Design Evolution of Civic Square

This booklet demonstrates the design review process in Seattle. It shows the evolution of the design of Civic Square as a result of a series of six reviews by the city's Design Review Board and Design Commission.

Project
Civic Square, at 700 4th Ave., is the third and final component of the masterplan for the city's three block campus in downtown Seattle. The first two parts, City Hall and the Justice Center, were completed in 2002 and 2003.

1. Evolution of the Plaza and Circulation

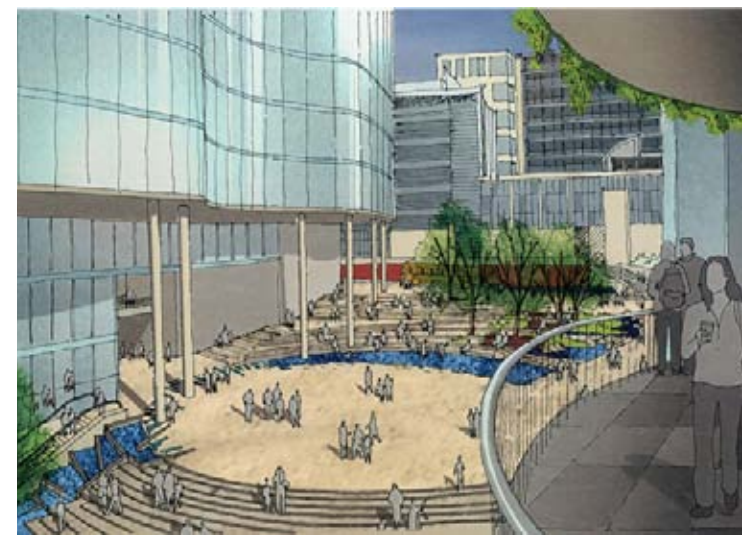
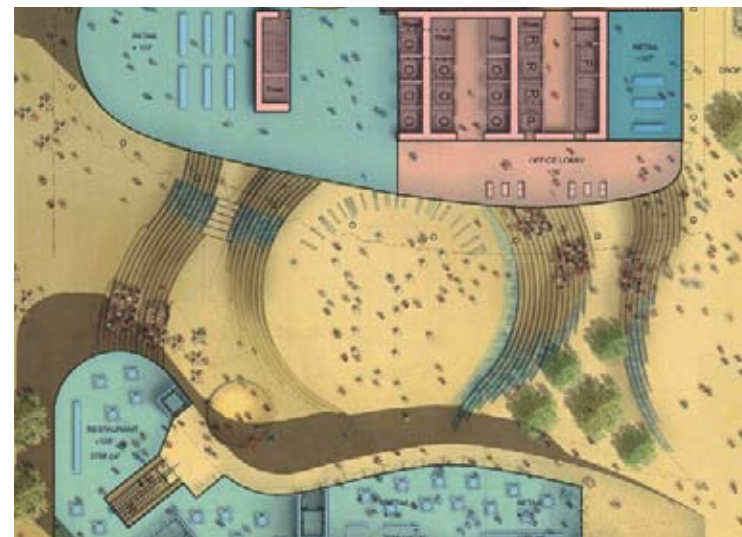
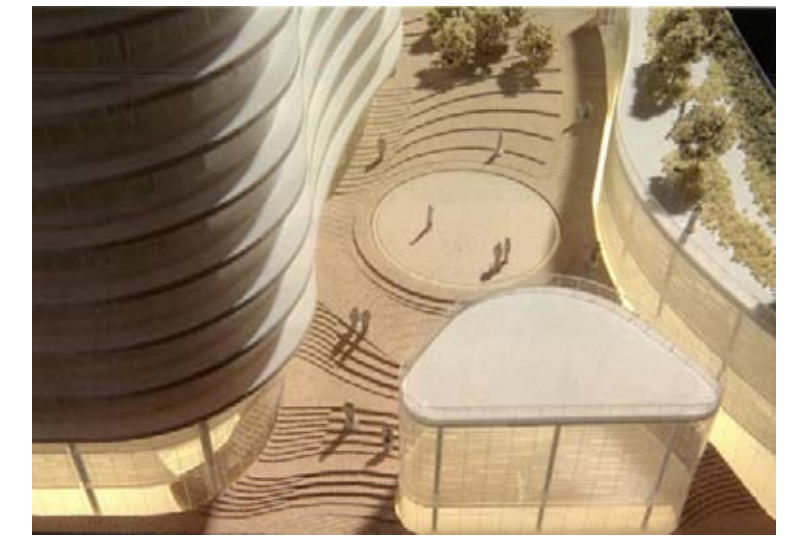
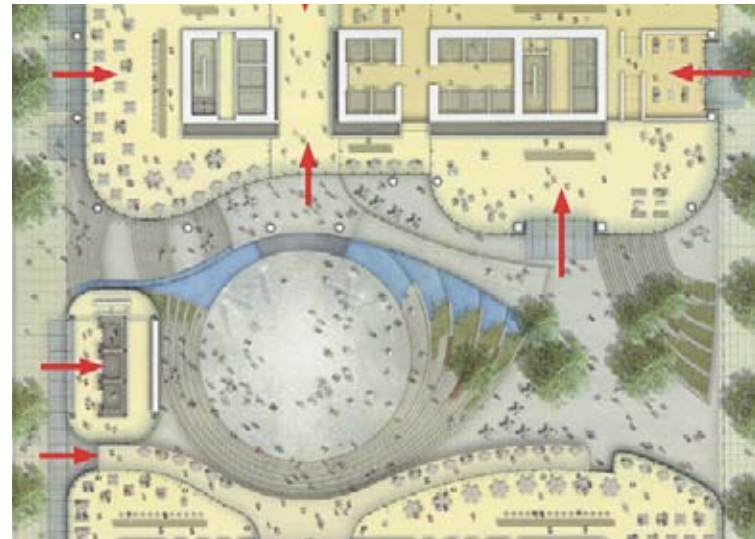
- » Create a variety of pedestrian paths through the site.
- » Integrate paths with the plaza, the Metro station and the tower.
- » Develop a design which treats the site grade as a positive condition.
- » Prioritize the circulation patterns.
- » Create a design that recognizes that people will use the plaza for multiple reasons.
- » The flat portions of the open space will not be animated when not housing a festival or some large gathering of people.
- » The public space appears too homogenous and needs more variety. It also needs to be accessible
- » The "mountain to city to sound" concept ought to be abstracted in the design; taken too literally, the idea risks becoming a cliché.

- » The framework of the plaza has not changed.
- » Imbue the plaza with more personality and greater diversity of spaces
- » The big idea -- the cascading steps and water -- also needs smaller ideas

- » Create intimate sanctuaries for gathering.
- » Add more clusters of trees and vegetation
- » Find a balance of water features and of rough and sleek materials

- » Reduce the amount of space devoted to steps and develop more spaces for lingering.
- » Redesign the area at the foot of the steps along Third Ave. and make a stronger connection to the City Hall steps at Fourth Ave. and James St.

- » The placement of the escalator at the corner of the retail building, Third Ave. reduces the ability to draw people to the plaza.
- » Add significant landscape elements and/or retail to the plaza along Third Ave. Use these elements to bifurcate the space in front of the stairs.

- » Evaluate the Wells Fargo plaza on Second Ave. as an example of the paradox of a successful plaza that appears unable to support retail.

- » The plaza still needs more small gathering spaces.
- » The portion of the plaza on the south side of the tower would receive the most activity due to the solar exposure.
- » Encourage the location of cafes and restaurants along the plaza. Too much circulation is hugging the south side of the tower.
- » Imbue the plaza and the proposed structures with materials from City Hall and the Justice Center to create a sense of continuity. Select materials and landscaping should assist in creating a unified scheme.
- » Organize the plaza so that Fourth Ave. could be closed off for large events.

- » Round the base of the tower more to enhance the sense of enclosure surrounding the plaza.
- » Approves the singularity of the designers' vision of the plaza.
- » The plaza concept has not significantly changed. The plaza still needs more intimate and distinct places within the larger plaza.
- » Learn from the barren City Hall plaza with its copious amounts of concrete and too few trees to shade its users.

→ The final plaza design offers more activity space and less reliance on the grand gestures of cascading steps and a formal pavilion. The landscape architect added a series of more discrete spaces for lingering connected by a water feature. The revised plan encourages a wider range of activities.

→ Fewer steps are on the plaza.

→ The plaza has more gathering places and is moved east.

2. Evolution of the Shape of the Base

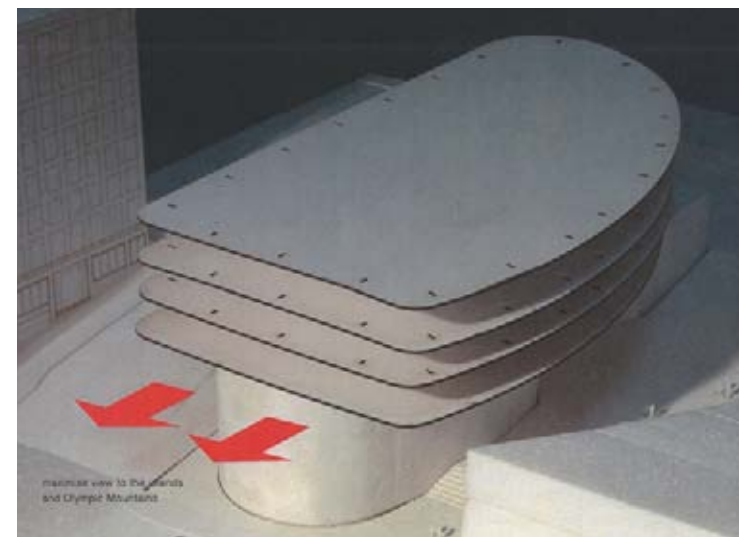
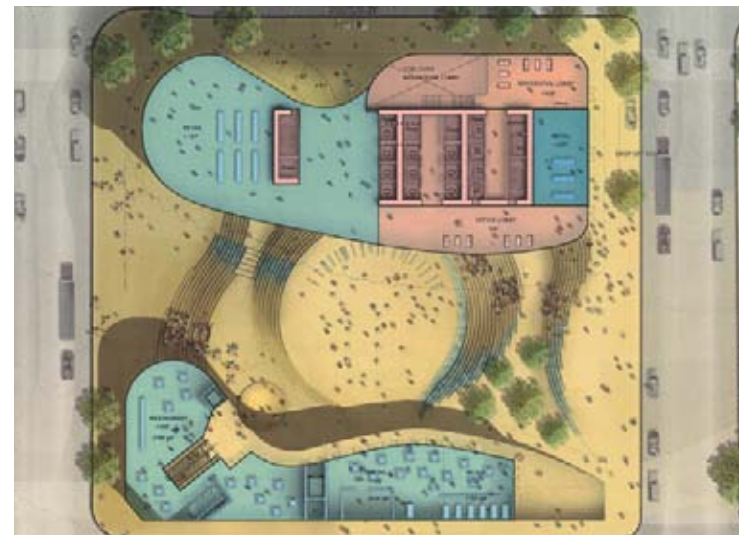
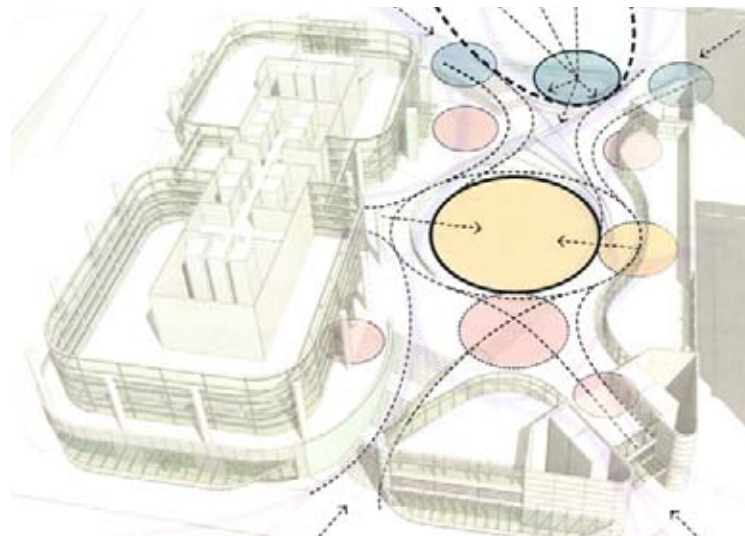
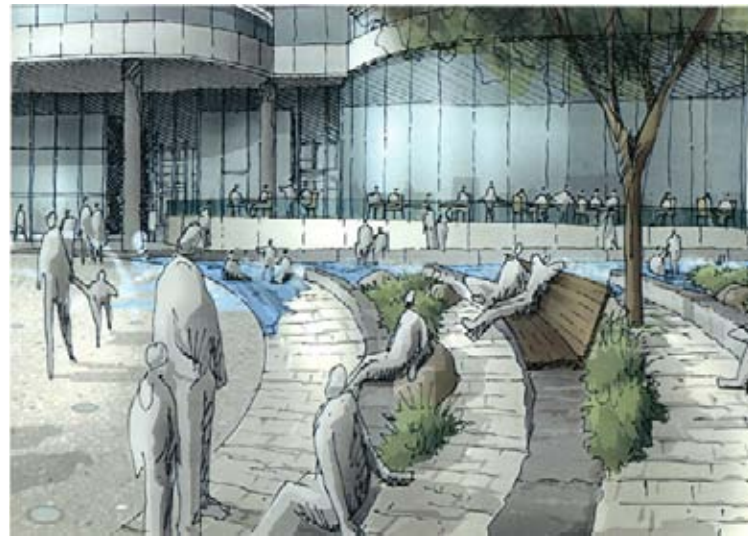
- » The footprints of the tower and the retail building reduce the width of the plaza directly exposed to the sky to about the size of the adjacent rights of way.
- » The basic wing-like form of the office volume is an appropriate form.
- » The extent of the overhang into the mid-plaza area diminishes the plaza's quality as a major public place.
- » Redesign the concave plaza and the convex shaped tower to find a better marriage between the two.

- » Relate the datum line expressed in the overhang and in the retail and Metro pavilions to adjacent buildings.
- » Design the entrances, fenestration, materials, canopies and structural system to contribute to the streetscape with the same exuberance as the neighboring landmark buildings. Respond to the richness of the surrounding structures.

- » In plan, the final design of the base with two co-joined squares with rounded corners solves circulation problems and creates a pleasing backdrop to the plaza. The base has a double height glazed wall facing the south which acknowledges solar conditions and the connection between activities both inside and outside on the plaza.

» Base is two rounded dumbbells.

3. Evolution of the Access to the Transit Station

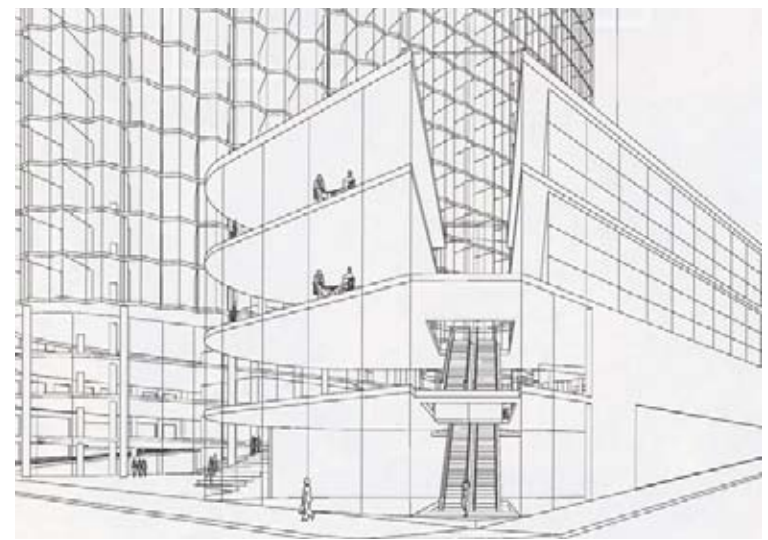
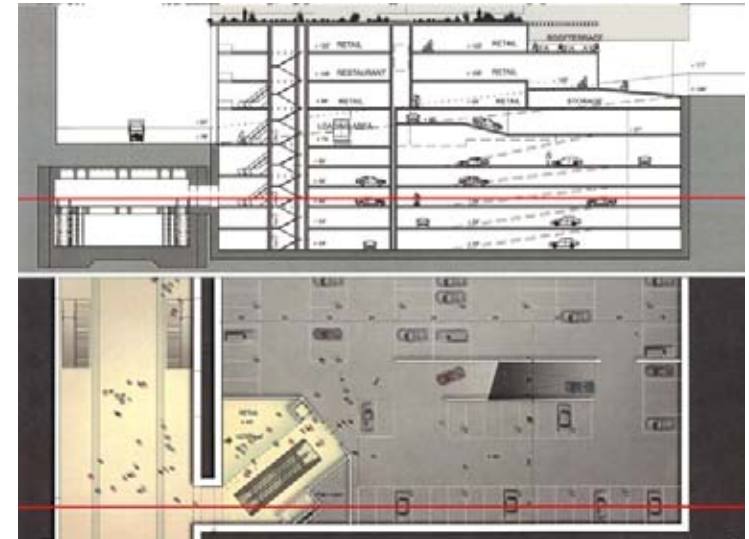
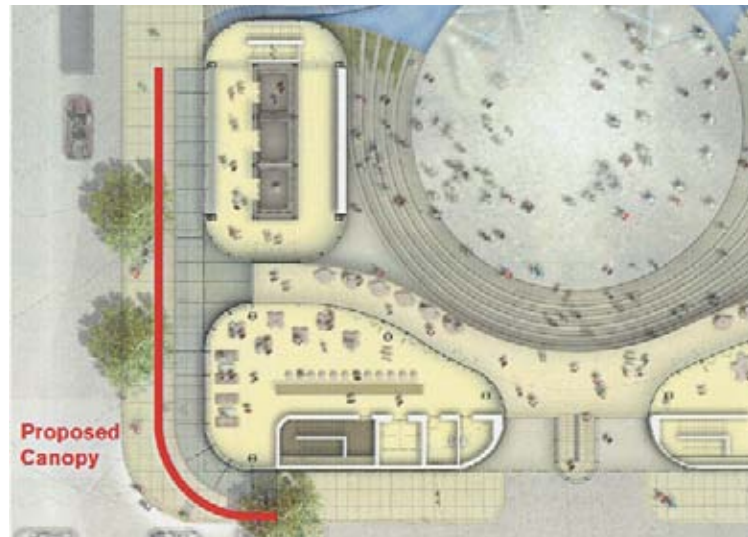
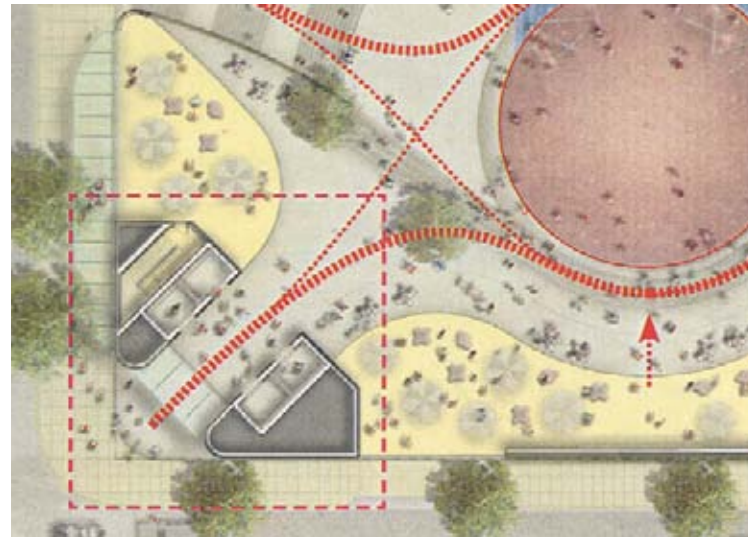
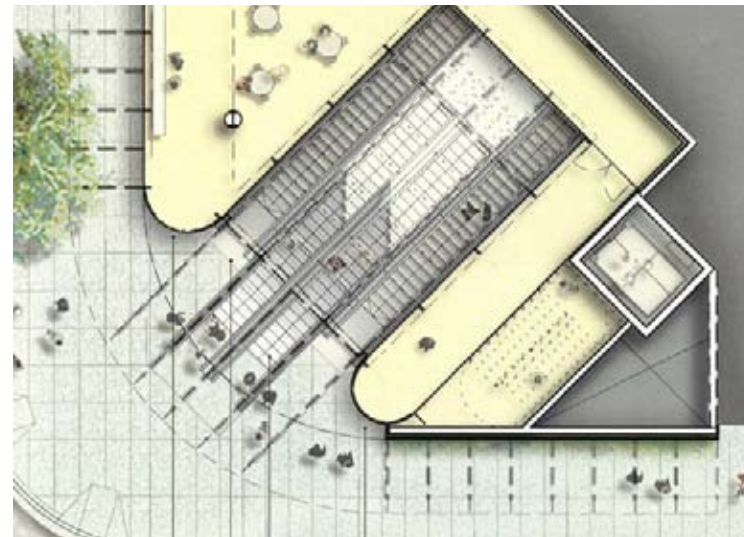
- » The shift in the escalator's placement leaves a largely undeveloped open space along Third Ave. at the foot of the steps and places the arriving pedestrians from the station directly behind the People's Pavilion, which would be awkward during performances.

- » Redesign the circulation system from the Metro tunnel to the plaza, as it is awkward for pedestrians to use two sets of escalators in two different buildings to access the plaza. The connection to Metro should be direct and obvious from the plaza.
- » The space along Third Ave. is too small and not gracious enough to accommodate the anticipated number of transit riders.

- » The elevator's lack of visual clues as a route to the plaza hinders the design. Escalators provide a strong visual connection to the plaza.
- » The massing of the metro pavilion needs a stronger expression of verticality and an identity distinct from the design of the overall complex. The Metro pavilion and the retail pavilion on Third Ave. look large when in reality these structures would be small in contrast to the tower and nearby buildings. Reconsider the design of these structures to reflect their intimate size.

- » The elevator tower could also be quite fun and more a whimsical structure.
- » Passage through the site without the use of an elevator is important. The removal of the escalator at the Metro and retail pavilion requires installation of a direct connection to the plaza from the site's southwest corner

- » The lack of an entry or a gateway to the plaza from Third and James is troubling. The Third and James corner is important for pedestrians in the Pioneer Square neighborhood. The loss of the steps, the lack of a door into the retail space and the blank walls along James St. suggest that the design is turning its back upon this area and its pedestrians.

- » Gang the retail elevator, exit stairs, and the bike storage area within the Metro elevator pavilion.
- » Approve of the shift of the Metro station from Third Ave. to the corner at Third and Cherry streets.
- » The corners are fortress-like, particularly at both corners of James St. The corners and the James St. façade starkly contrast with "the magical world of the plaza." What should be gateways to the plaza appear more like barricades.

- » This design produces a better connection among the relationships of the street, the plaza and the Metro station.

» After exploring many options for transit station access, the architect returned to the use of escalators. The final design possesses the clearest pedestrian access to the different levels within the site, creating a more welcoming gesture to the building's public spaces -- the plaza above, the transit station below and the streetscape itself. The escalators' openness to the street corner was unachievable by elevators.

» Elevators are removed. Escalators at Third Ave. and James St. connect plaza, street, transit station and retail pavilion.

5. Evolution of the James Street Facade

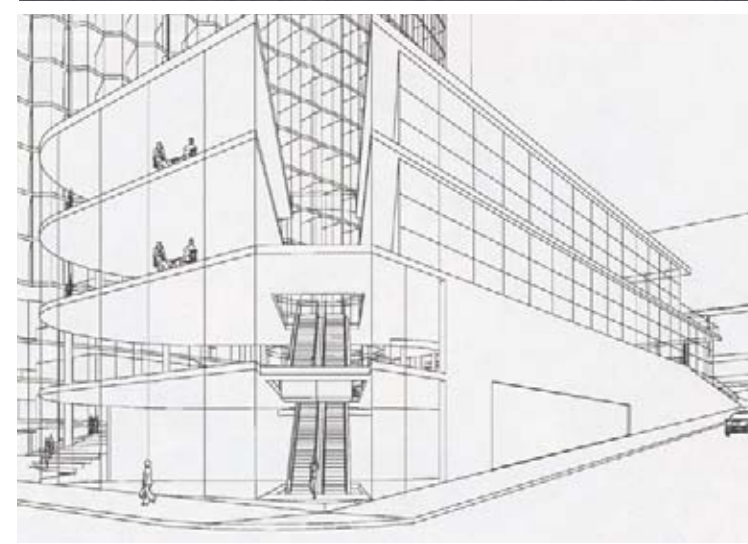
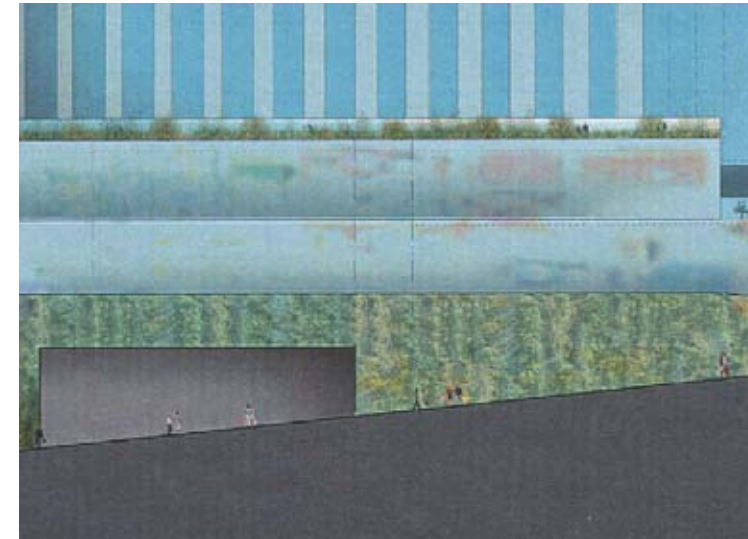
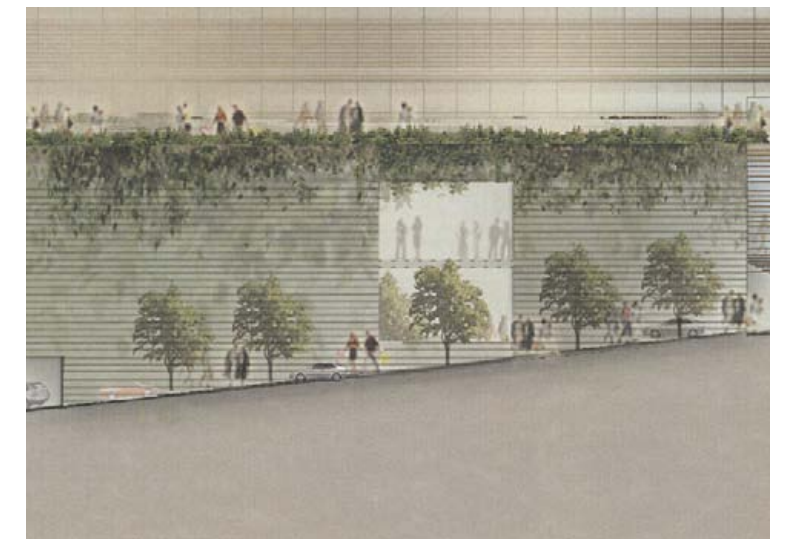
- » Create an attractive James St. facade. Even with the presence of the vehicular service area on James St., the design of the facade should not entirely turn its back to the street. Blank facades and garage doors should be well designed. The facade and entry points should suggest the civic nature of the space behind it.

- » Showcase environmentally sustainable features along James St. in keeping with the proposed green roof above the retail pavilion.
- » Retain the idea that the lower elevation's appearance along James St. could be a mostly solid or opaque base supporting a delicate, glassy structure without sacrificing a pleasant pedestrian experience on James St.

- » Although James St. will house service and vehicular entrances, the pedestrian realm should not be overlooked. The Board encouraged the architects to incorporate overhead weather protection, the escalator and the green wall into one integrated element comprising the James St. facade.

- » Board members noted the large expanse of the green wall on James St. Greater penetration of the upper levels would provide views to the south from the restaurant.

- » Add more transparency to the James St. facade and choose interesting materials and detail beneath the green wall to ensure a good facade even when the wall lacks foliage.

- » Overhead weather protection should be integrated into the James St. facade in places it won't interfere with service and vehicular entries.

» The green wall on James St. is devoid of context.

- » The blank wall along James St. is mostly inhospitable to pedestrian comfort and safety. Redesign the James St. elevation to provide more transparency and literally connect the green screen to the sidewalk level and allow the green roof to cascade over the wall to join the green screen.

- » Revise the green screen and add overhead weather protection along the façade. The green screen on the south elevation of the retail pavilion appears appliqué and is detached from the roof top as well as the sidewalk level. It covers service functions which in themselves could be wonderfully expressed on the exterior. The green screen does not satisfy the zoning code's requirements in portions of the facade. At Third Ave. and James St., the design of the Metro access pavilion lacks any visual clue that it connects to the Metro station or the plaza above the sidewalk grade. The proposed monolithic corner elements framing the entrance should be more welcoming and attract people to the plaza.

- » At Fourth Ave. and James St., an entirely opaque prow containing an exit stairs makes little sense at this important corner.

- » Approves the changes to the James St. façade with its modulations mimicking the tower and amenities for pedestrians.
- » The lack of continuity in the overhead weather protection does not significantly impact the intent of pedestrian protection during inclement weather.

- » Recommends a departure from the Land Use Code for the series of discontinuous canopies stepping up the slope of James St .
- » Approves the redesign of the James St. elevation, with modifications to the continuity of the canopies, the amount of transparency at the Fourth Ave. and James St. prow, whether or not the vitrines animate the street front, and the connection between the green screen and the green roof.

- » Achieve a stronger relationship between the green wall and the roof top of the retail pavilion. Increase the transparency from James Street through the stair well at the Fourth Ave. end of the retail pavilion to better connect James St. to the plaza.

» The final James Street design offers pedestrian oriented features such as store front displays and overhead weather protection. The design also creates a more pleasing rythm of green landscape features that brings a sense of human scale to the blank walls.

» Storefront displays and overhead weather protection at street level, green wall above.
